**KNOXVILLE HISTORIC ZONING COMMISSION
STAFF REPORT - CERTIFICATE OF APPROPRIATENESS APPLICATION**

PROPERTY ADDRESS: 101 E Fifth Ave 37917

FILE NO.: 5-D-16-HZ

▶ **DESCRIPTION OF WORK:**

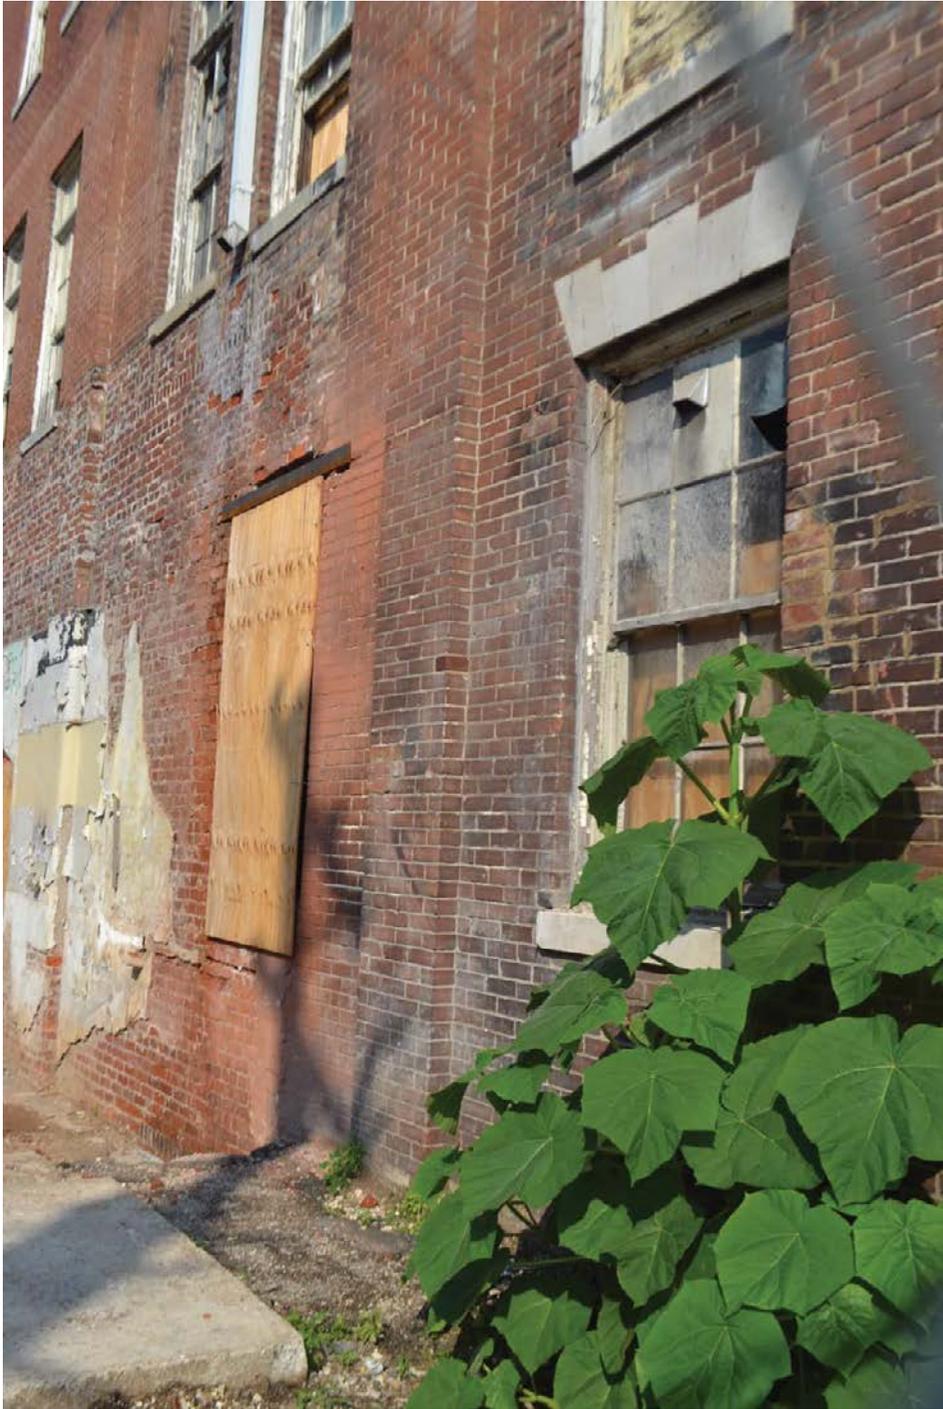
Missing sashes and muntins on N. Central Street upper level

Missing sashes and muntins on N. Central Street upper level

Missing sashes and muntins on N. Central Street upper level

Missing windows in courtyard

Bottom window sash missing

Deteriorated sash and sill

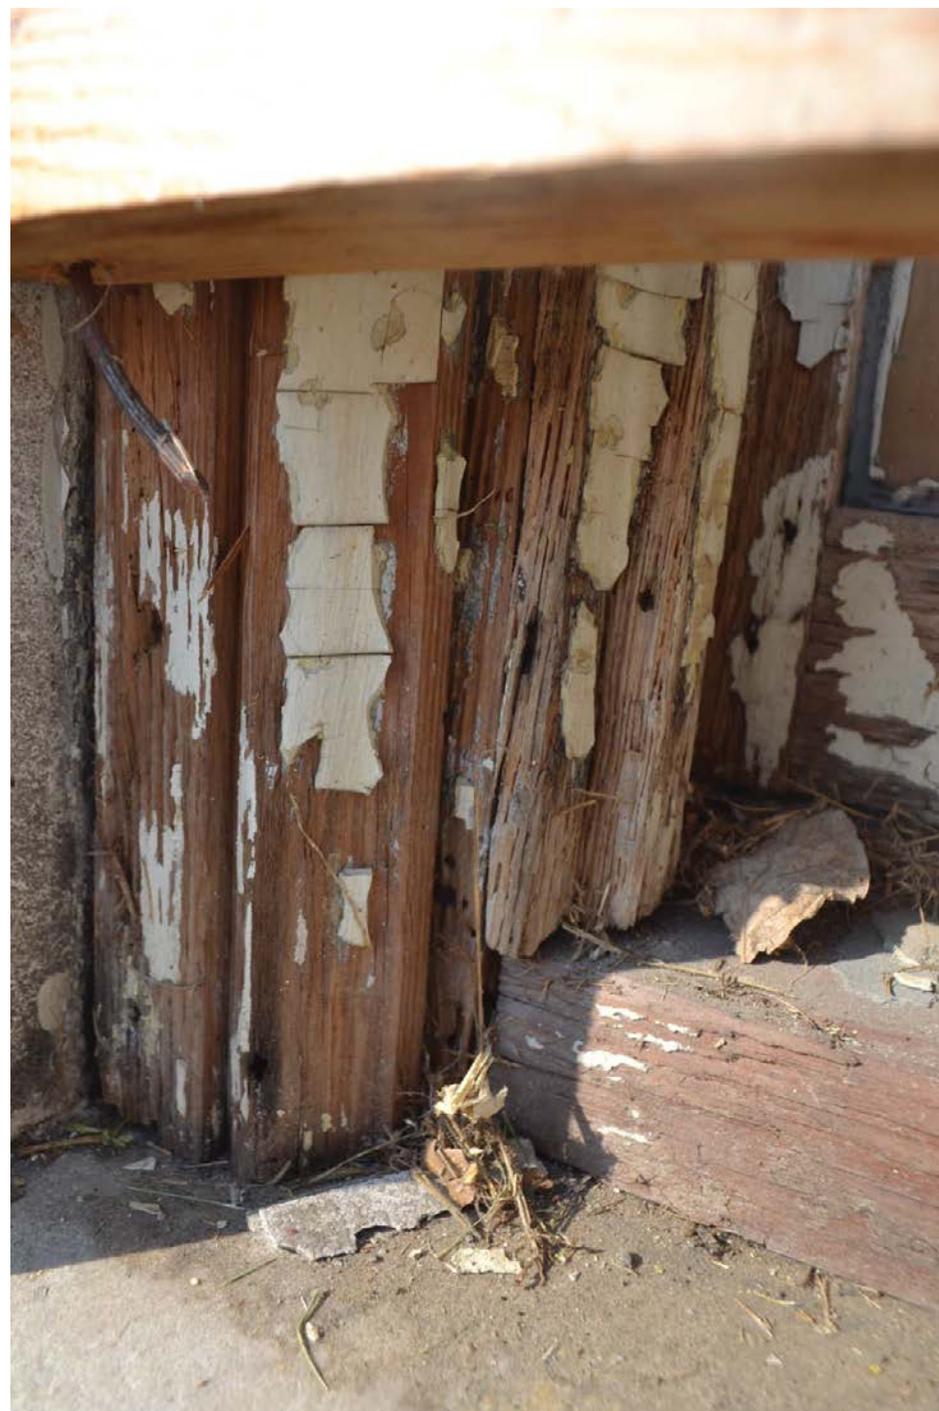
Rot at bottom of frame

Rot at bottom of frame

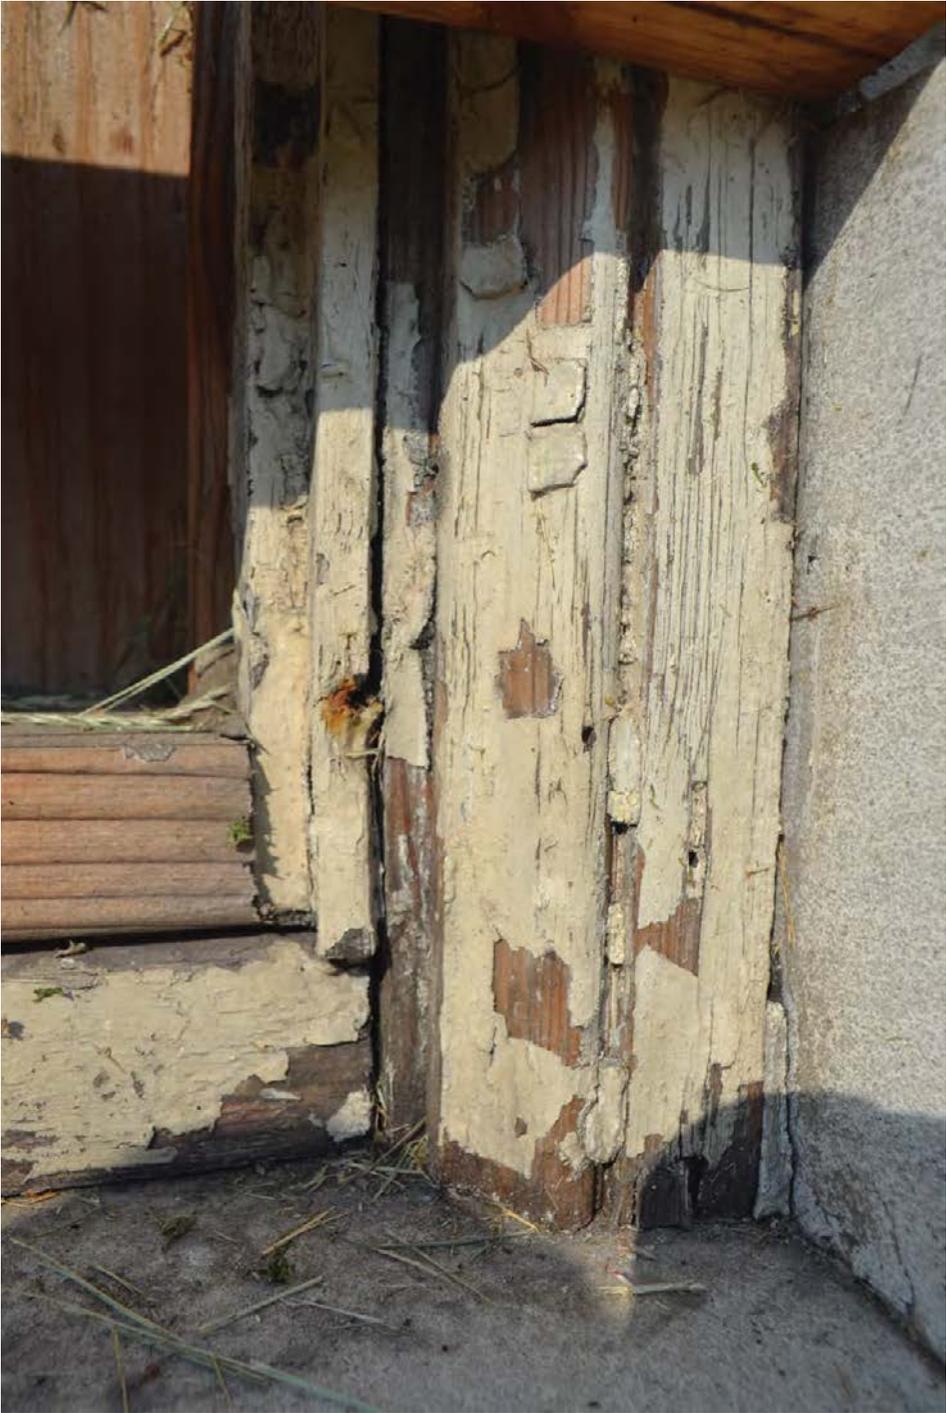
Rot on SW side window frame

Rot on SW side window frame

Deteriorated muntin
